Re: Question Construction Building, 2212 4th Street NW, Traffic Circulation Layout
Architect's Stamp dated 05-05-10 (H14-D103)

**Re: Question Building, 2212 4th St NW, Grading and Drainage Plan
Engineer's Stamp date 11-4-09 (H14/D103)**

**RE: Question Building, I-40 Northerly Frontage Road westbound,
I-40, MP 158.5**

Re: Queston Building, 2212 4th St NW, Grading and Drainage Plan
Engineer's Stamp date 9-14-09 (H14/D103)

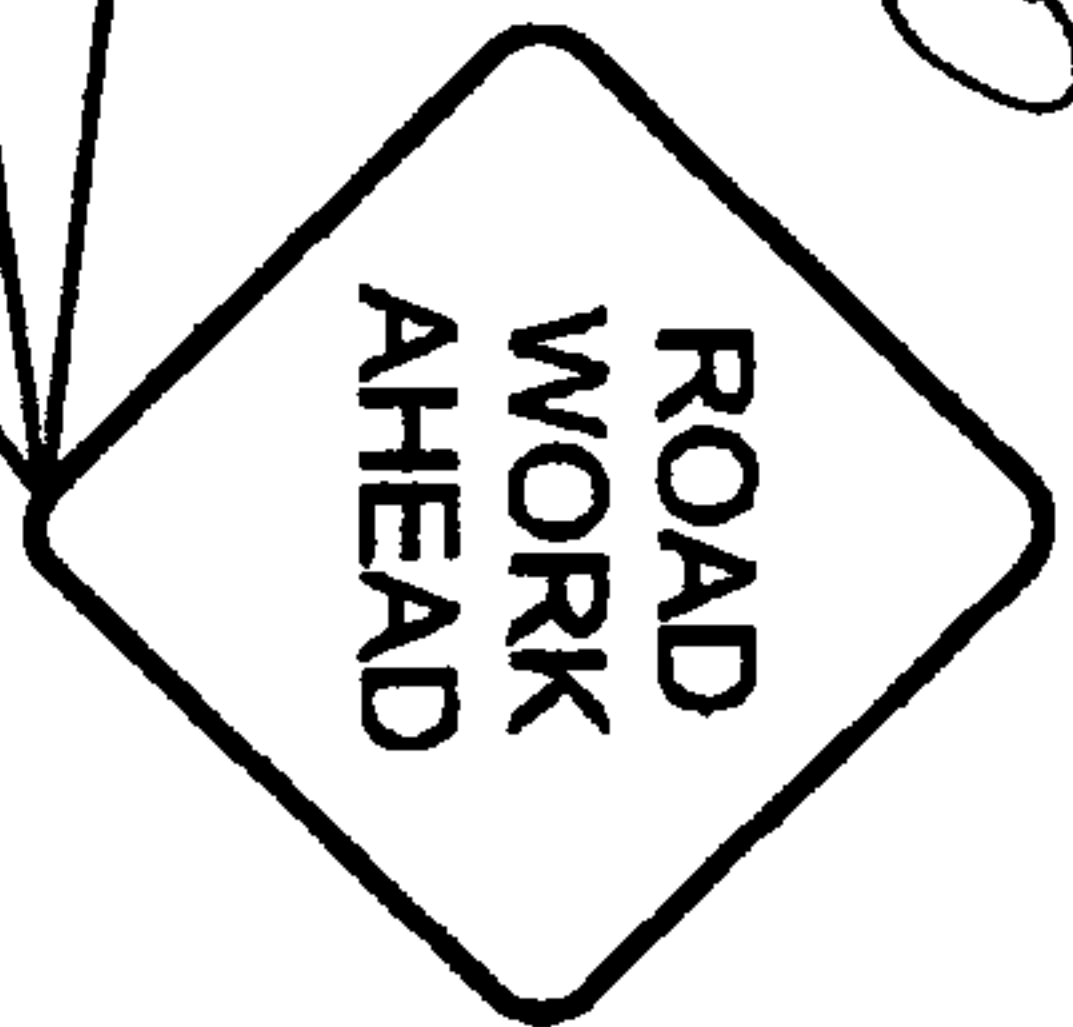
*Corrected
as amended
02/04/10*

GRADING & DRAINAGE PLAN

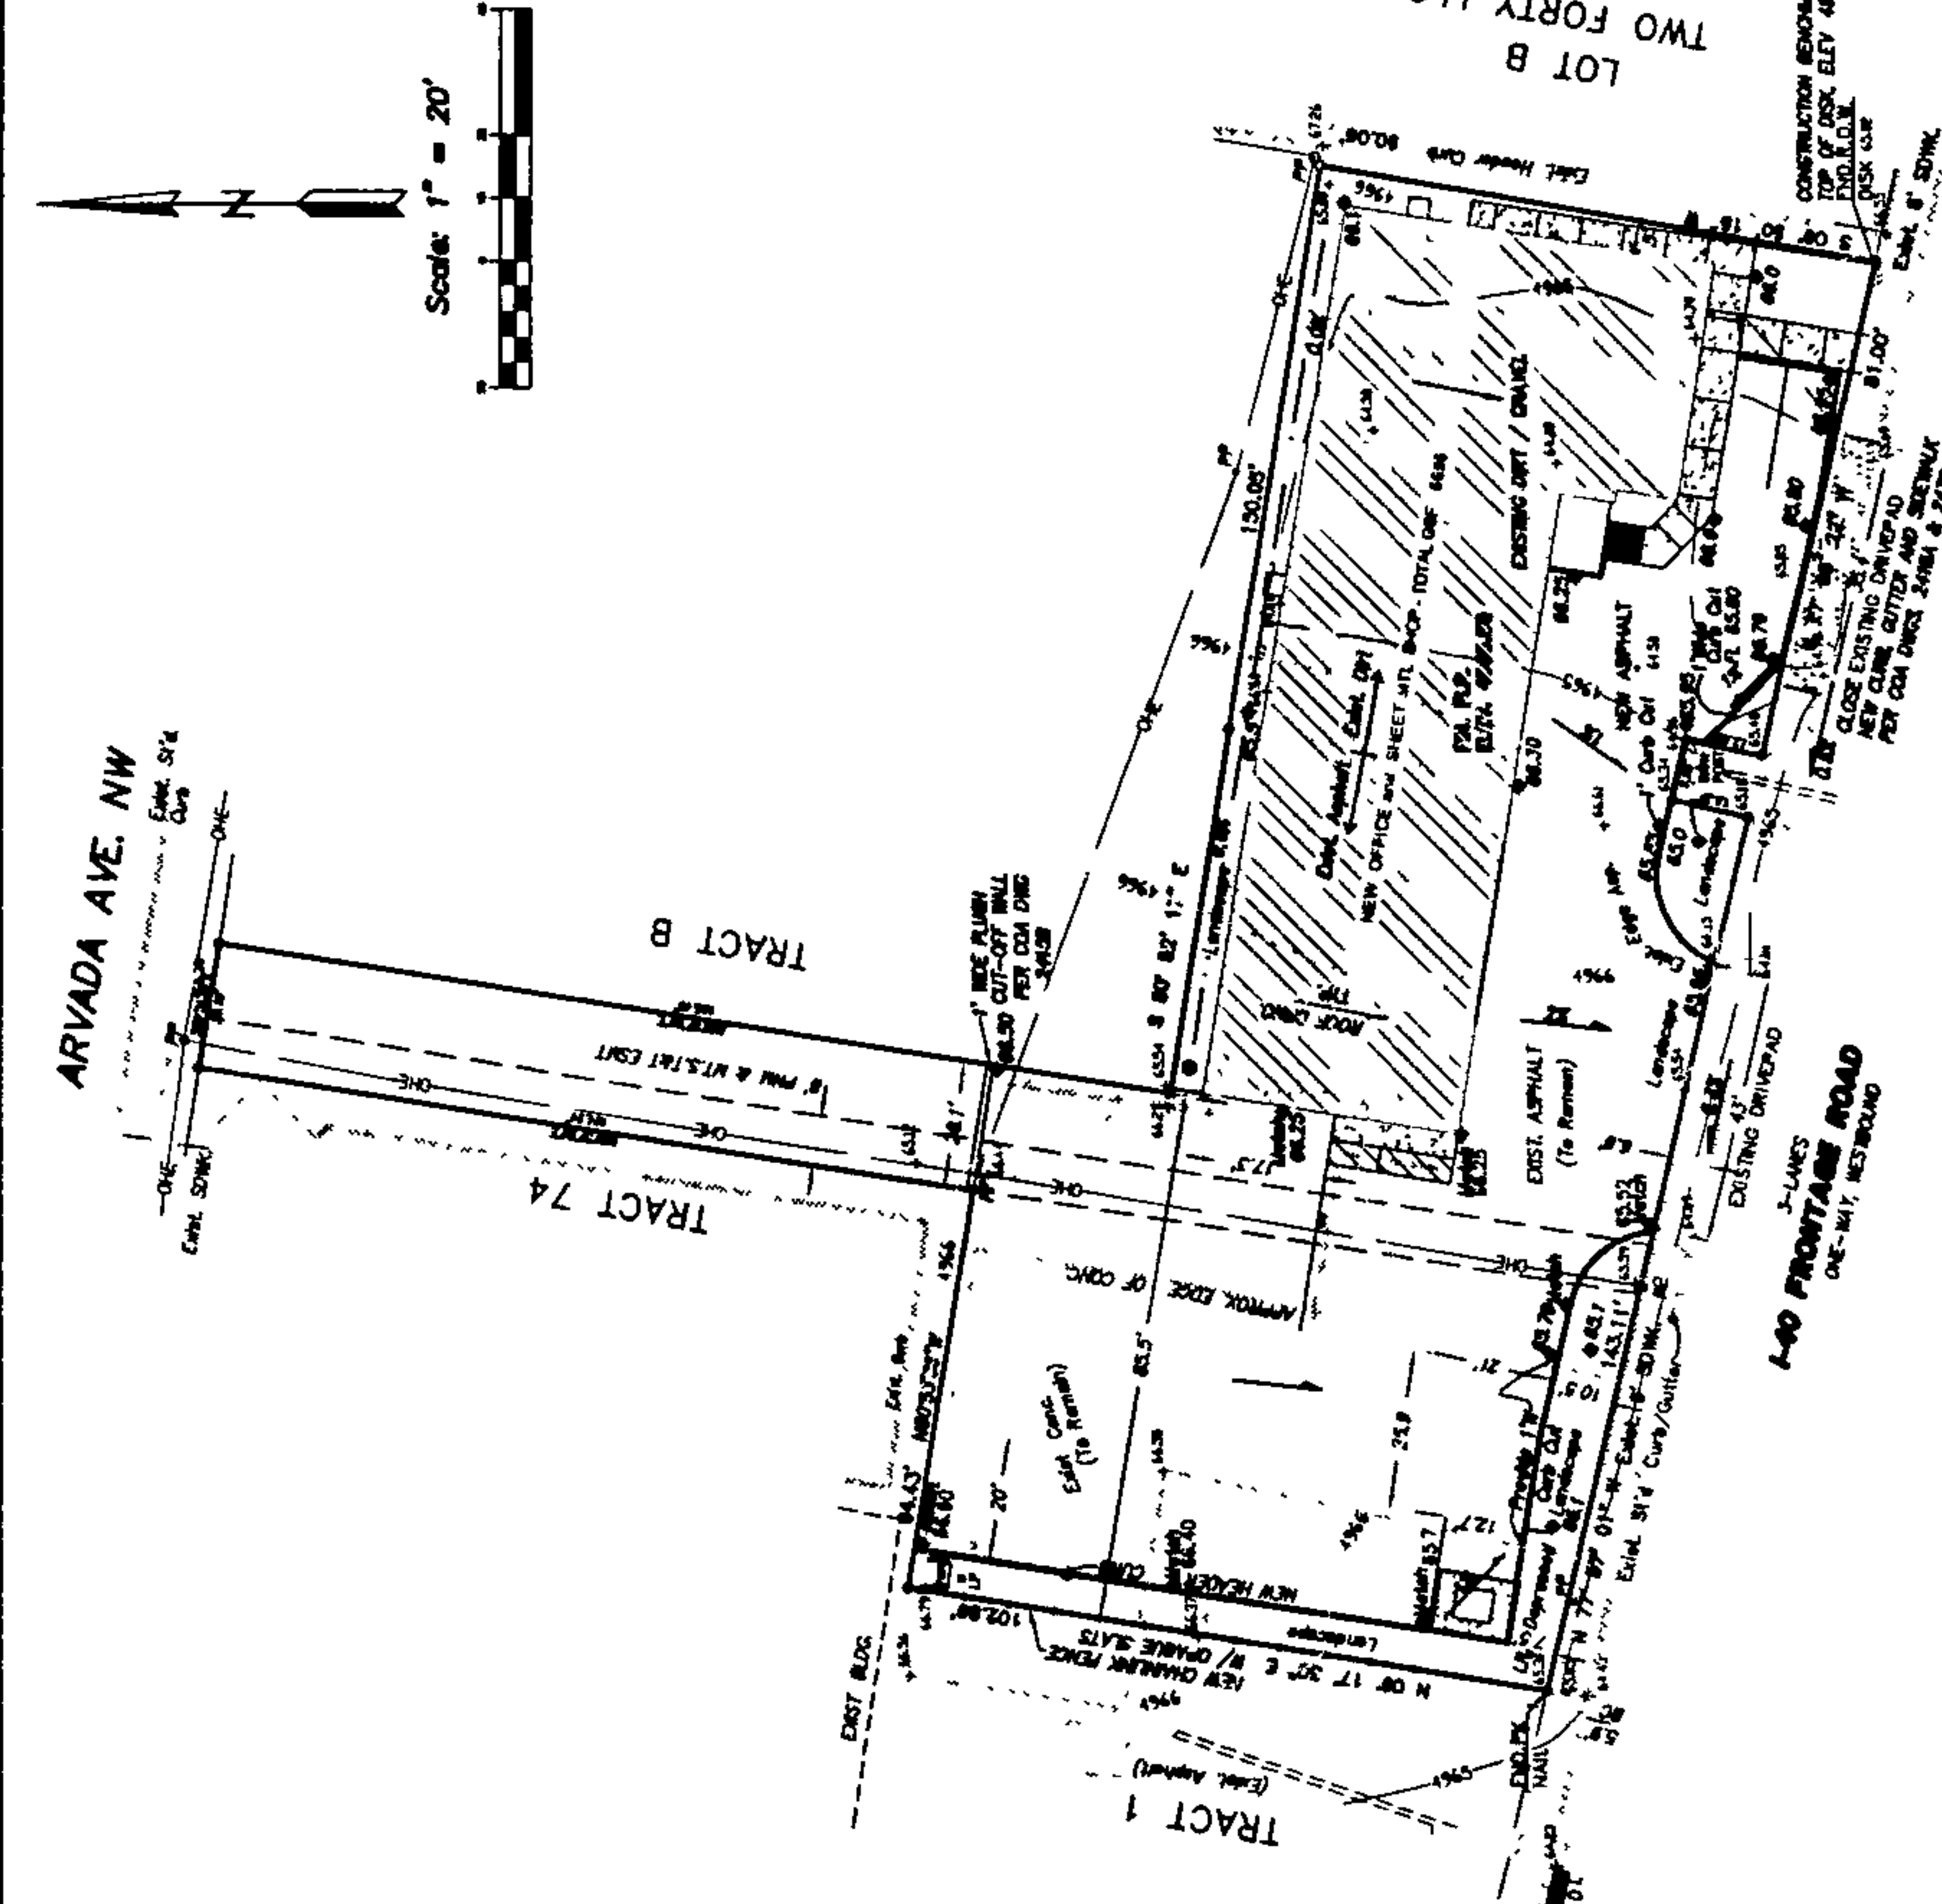
- NMDOT approval is required. Provide correspondence.
- The lot to the north is flush or slightly lower than this site. Depress the landscape area north of the building or similar to prevent runoff from crossing the property line.
- The FIRM Map provided is too dark. This site has an AO zone on its south boundary. This should be discernable on the FIRM or discussed in the narrative.

NOTE: SITE IS ADJACENT TO AN AD FLOODPLAIN THAT IS CONTAINED WITHIN THE STREET AND RIGHT-OF-WAY. THEREFORE THE FINISH FLOOR ELEVATION OF THE PROPOSED BUILDING IS SET 16 FEET ABOVE THE FLOWLINE OF THE I-40 FRONTAGE ROAD.
